## Appendix A

### Response-to-Comment table

**Comments from Related Departments**

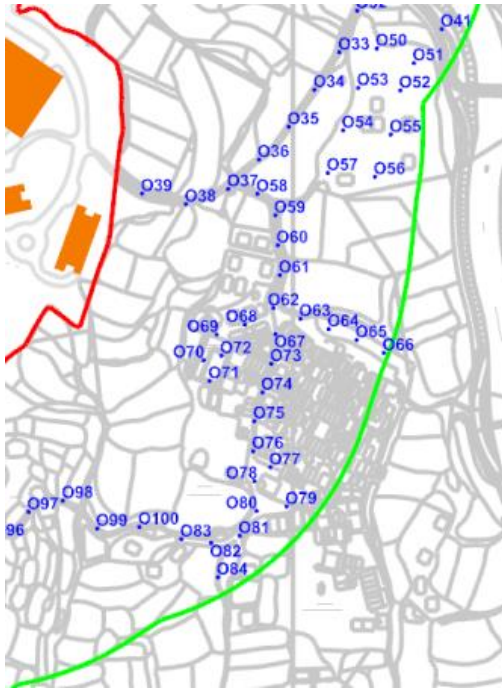
- The applicant should review the proposed layout plan to preserve the existing trees within the site as far as practicable, particularly for existing large trees with height of 14m and more and DBH exceeding 500mm, such as T15, T195, T251 and T322...etc.
- The applicant should explore the opportunity for more tree planting to meet 1:1 in terms of aggregated DBH when there is available planting space and

Given most of the existing large tree condition are considered as poor form and structure condition, the defects of each large trees are indicated in the Appendix B Photo Record of the Landscape and Tree Preservation Proposals (**Appendix C** refers).

In addition, the condition of existing trees (T186-T204) along the proposed buffer planting areas have been reviewed and preserved as far as practicable.

Figure 29 Location of Special Test Points

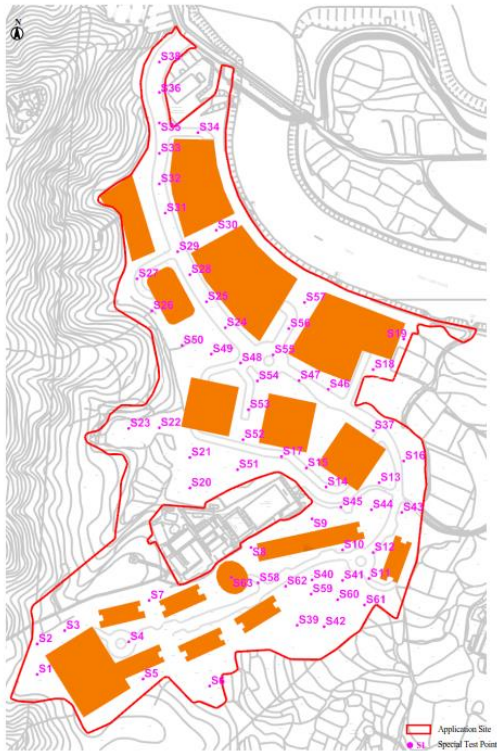
- Special Test points should be placed along all mitigation measures and grouped into individual focus areas to evaluate their effectiveness. We note that Special Test Points within the airpaths as marked below are missing.

Additional Special Test Points and focus areas have been added for the three air paths. Please refer to Tables 10 and 11.
